STAFF REPORT: CITY OF TRINIDAD

APPLICATION NO: 2012-02
OWNER(S): Glenn & Janis Saunders
APPLICANT / AGENT: Thomas Noonan Contracting
PROJECT LOCATION: 355 Main Street
PROJECT DESCRIPTION: Design Review and Coastal Development Permit for a remodel of the 859 ft² Catch Café with an addition of 351 ft² for indoor seating.
ASSESSOR'S PARCEL NUMBER: 042-063-036
ZONING: C - Commercial
GENERAL PLAN DESIGNATION: C - Commercial
ENVIRONMENTAL REVIEW: Categorically Exempt from CEQA per §15301 of the CEQA Guidelines exempting minor alterations of and additions to existing structures.

STAFF REPORT: CITY OF TRINIDAD

PROJECT DESCRIPTION: Design Review and Coastal Development for the construction of an attached, but separate, 504 sq. ft. addition to the approved 2,091 ft² Library building to house an office for the Land Trust.

PLOT PLAN DETAIL / FLOOR PLAN

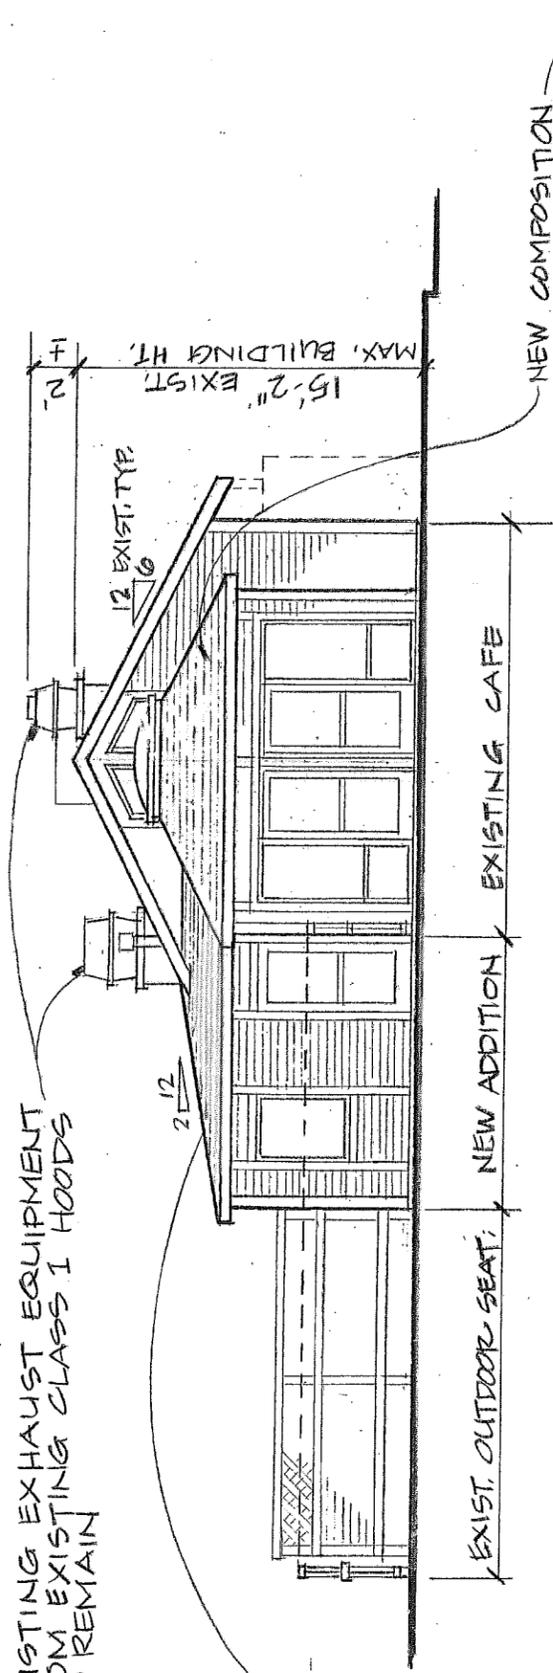
1. In accordance with the 2010 CBC, the proposed accessible curb ramp should include a detectable warning surface.
2. In accordance with the 2010 CBC, the slope of the accessible parking stall and access aisle should be limited to 2% maximum in any direction. *I assume the 2% applies to the stall itself and not the proposed ramp, which generally has an 8.33% slope except on the sides which are 10%.*
3. In accordance with the 2010 CBC, parked vehicles overhangs should not reduce the clear width of an accessible route. Consider adding wheel stops (parking bumpers) on the existing standard parking stalls and on the proposed van accessible parking stall to prevent vehicles from overhanging and obstructing the 4'-0" wide walkway shown on the plot plan.

The site plan notes that the applicant plans to develop a new accessible (van) parking space in the existing parking area in accordance with the 2010 CBC Chapter 11-B. A condition of approval for the Building Inspector to review these requirements as part of the building permit process has been included.

4. Building Inspector to review the proposed accessible parking space and associated elements for consistency with the 2010 CBC. The review shall include a detectable warning surface, the slope of the stall and vehicle overhangs / wheel stops.
